# Service Bulletin

Bulletin No.: 03-06-01-010

**Subject: Engine Oil or Coolant Leak (Install New Intake Manifold Gasket)**

100533

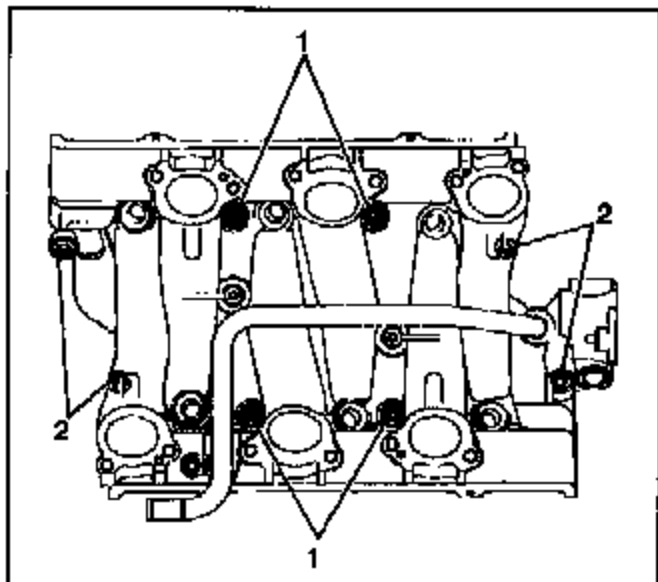
Install a new design intake manifold gasket. The material used in the gasket has been changed in order to improve the sealing qualities of the gasket. When replacing the gasket, the intake manifold bolts must also be cleaned, coated with threadlocker and torqued to a revised specification.

**Notice:** An oil leak may result if the vertical bolts are not tightened before the diagonal bolts.

Diagonal bolts may require a crows foot to tighten.

Clean all of the intake bolts of any debris or oils.

Be sure to apply threadlocker, GM P/N 12345382 (in Canada, P/N 10953489), to the bottom 3-4 threads of each of the intake bolts before installation.

1. Tighten the vertical lower intake manifold bolts (1) to 7 N-m (62 lb in).
2. Tighten the diagonal lower intake manifold bolts (2) to 7 N-m (62 lb in).
3. Tighten the vertical lower intake manifold bolts (1) to 13 N-m (115 lb in).
4. Tighten the diagonal lower intake manifold bolts (2) to 25 N-m (18 lb ft).
